## Accessibility Design Review Report

St. Michael's Uniting Church  
120 Collins Street  
Melbourne, Victoria

Dated: 09 December 2024

Reference: EG-241208-AC

EXISTING - VIEW FROM ADJACENT TITLE

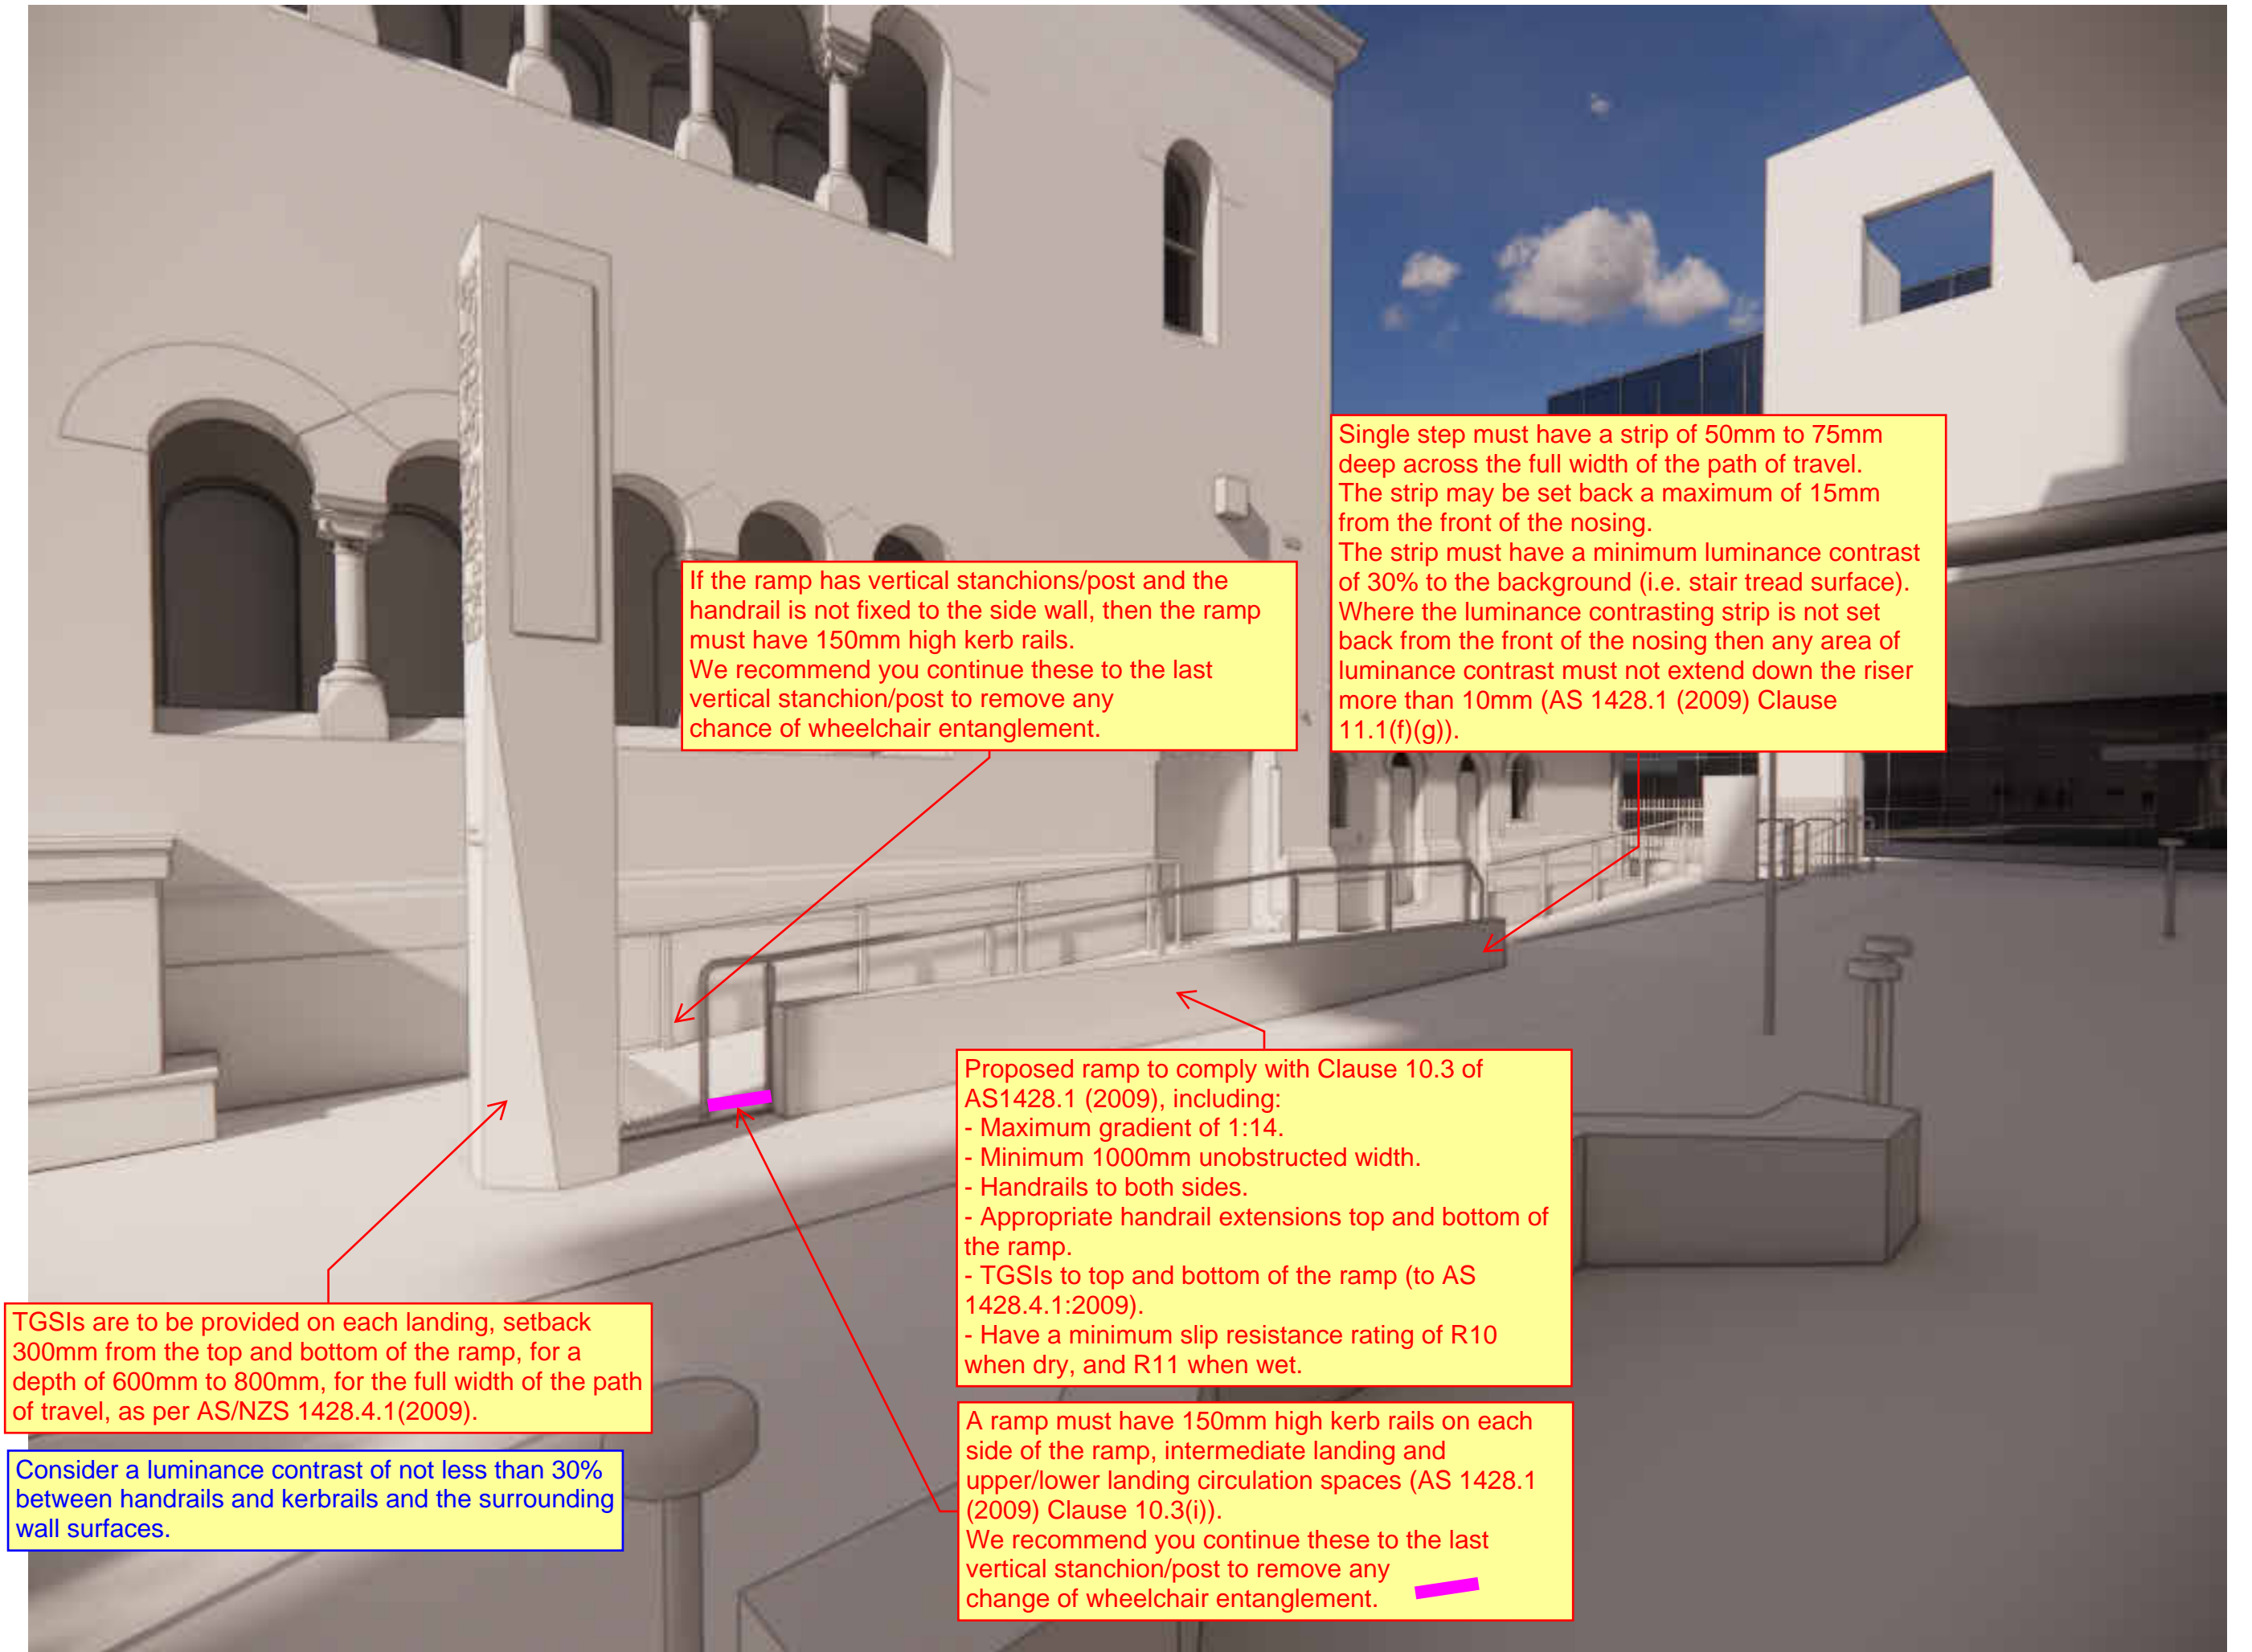
TGSIs require a luminance contrast against their ground background surface to help identify the hazard:
